AIRWORTHINESS DIRECTIVE

TYPE AFFECTED: Standard Cirrus S/N's 1 to 397, 399 to 572, 574 to 585, 587 to 592, 594, 596, 600.

SUBJECT: Cracking of the elevator attachment. (T-fitting).

FIGURE 1.

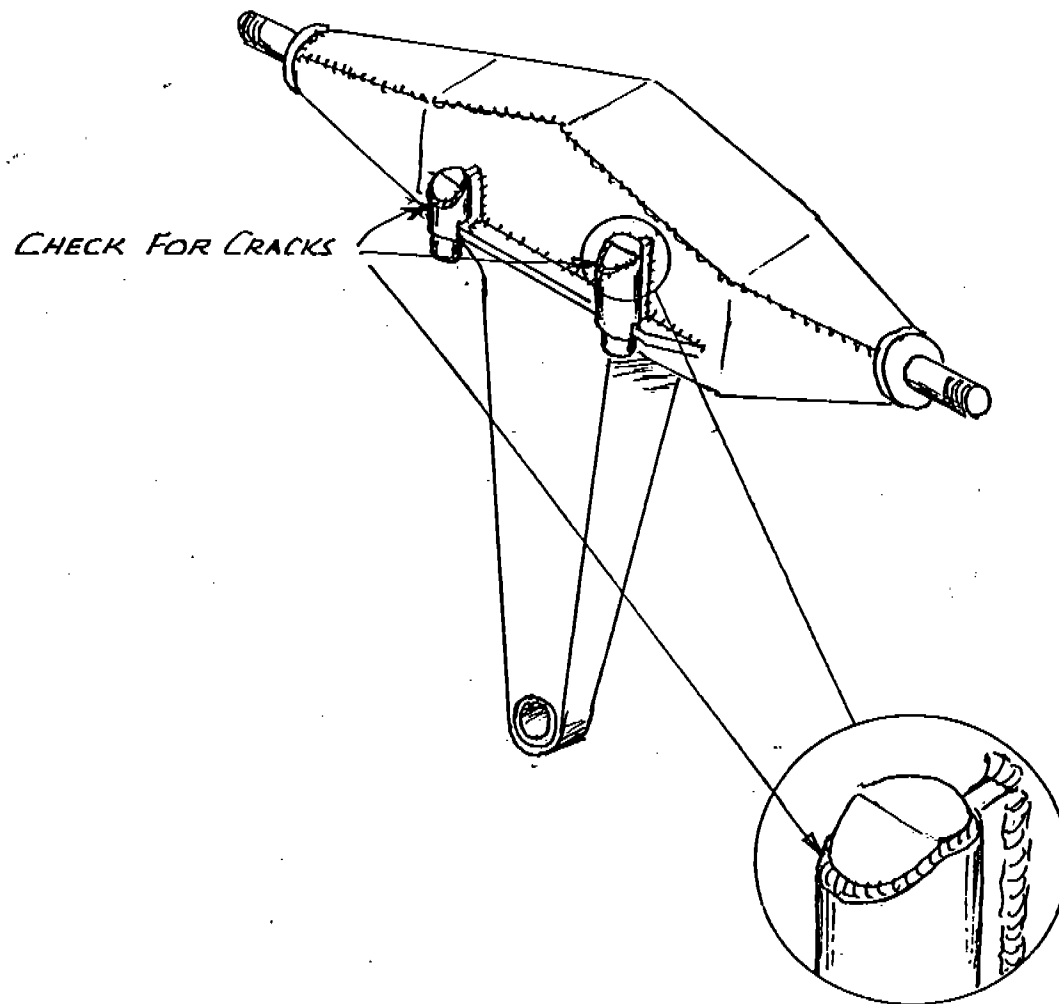
ACTION REQUIRED: **STANDARD CIRRUS:** At the next Form 2 Inspection or before 31 December 1980 and every 300 hours thereafter the T-fitting must be inspected in accordance with action 1 of TN 278-26 which forms part of this AD.

STANDARD CIRRUS B: At the next Form 2 Inspection or before 31 December 1992 and every 300 hours thereafter the T-fitting must be inspected in accordance with action 1 of TN 278-26 which forms part of this AD.

See figure 1 for clarification of the required inspection.
